CHANGE REQUEST NO. ILC-CR-00XX	EDMS No: D*xxxxxxx	Created: 27-10-2015
		Last modified: xx-xx-2015

THE CFS DESIGN COMPATIBLE WITH BOTH UNDULATOR SOURCE AND E-DRIVEN SOURCE

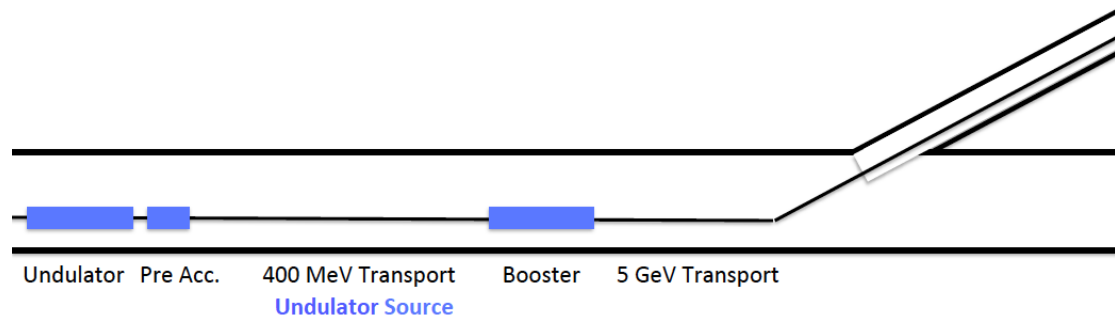
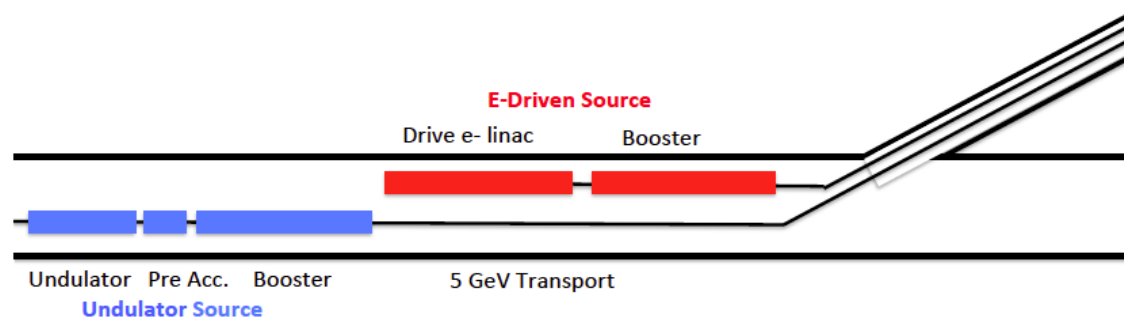
Make the CFS design compatible with both undulator positron source and e-driven positron source. The new design can accommodate both sources.

The required length of the e-driven source from the electron gun to the energy compressor for the positron is estimated to be ~1.1km(*). One of the possible location of the e-driven source is in the BDS tunnel at the downstream of the undulator source. In the TDR design, there is a long low energy (400 MeV) transport line between the positron pre-accelerator and the booster.

When we remove the 400MeV transport line and relocate the positron booster linac to upstream, there will be a long space which can accommodate the e-driven source longitudinally. . In this case the e-driven source is located(**) at the downstream of the undulator positron source side-by-side with the high energy (5 GeV) positron transport line of the undulator source, the electron BDS, and the electron transport line from DR.

At the location of the e-driven source, both the accelerator tunnel and the service tunnel may have to be slightly enlarged in transverse direction. It is necessary to make additional transverse enlargement and the radiation shielding at the location of the positron production target of the e-driven source. The required space for the e-driven target is similar or slightly larger than those of the undulator target. The detail of the necessary transverse enlargement will be a subject of future study.
